# PCN-20210618 TE0823-01 eMMC Change and Product Update

<b>Company</b>	Trenz Electronic GmbH
<b>PCN Number</b>	PCN-20210618
<b>Title</b>	TE0823-01 eMMC Change and Product Update
<b>Subject</b>	BOM change
<b>Issue Date</b>	2021-08-04

This change affects all Trenz Electronic TE0823 SoMs of revision 01: TE0823-01

Locate eMMC (U6) on bottom side of PCB:

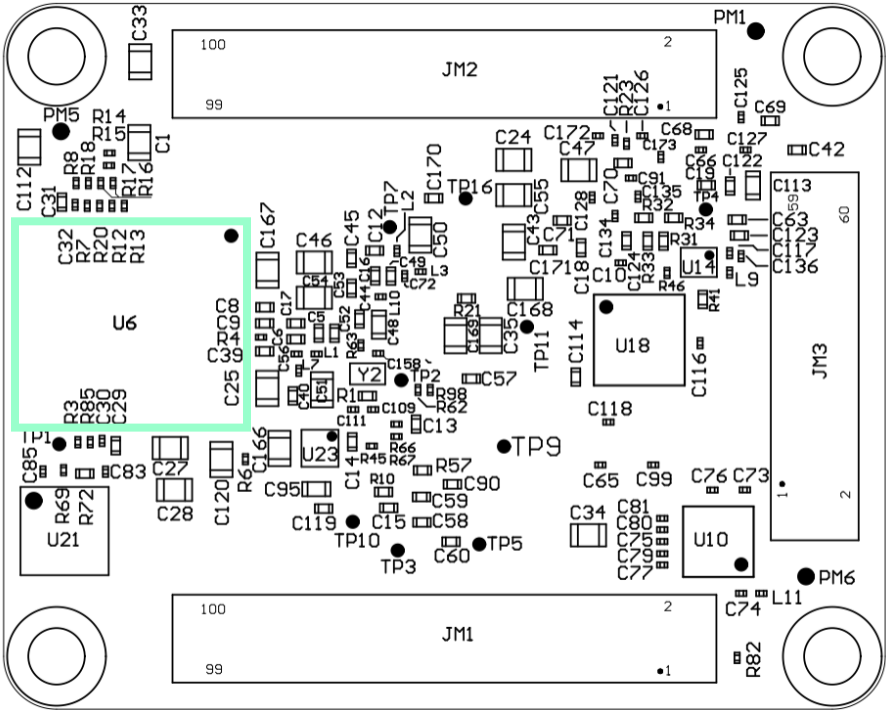
### #1 Change eMMC (U6) from IS21ES08G-JCLI to SDINBDG4-8G-XI2

**Reason:** Distributor informed about unforeseeable immediate EOL of parts. No official documents from manufacturer are available. No LTB, already confirmed orders were cancelled by distributor/manufacturer.

**Impact:** None. Replacement has same capacity as used on corresponding affected variant. Reference designs for vivado versions 2019.2 and 2020.2 were tested and work properly without any changes.

old	new
IS21ES08G-JCLI	SDINBDG4-8G-XI2
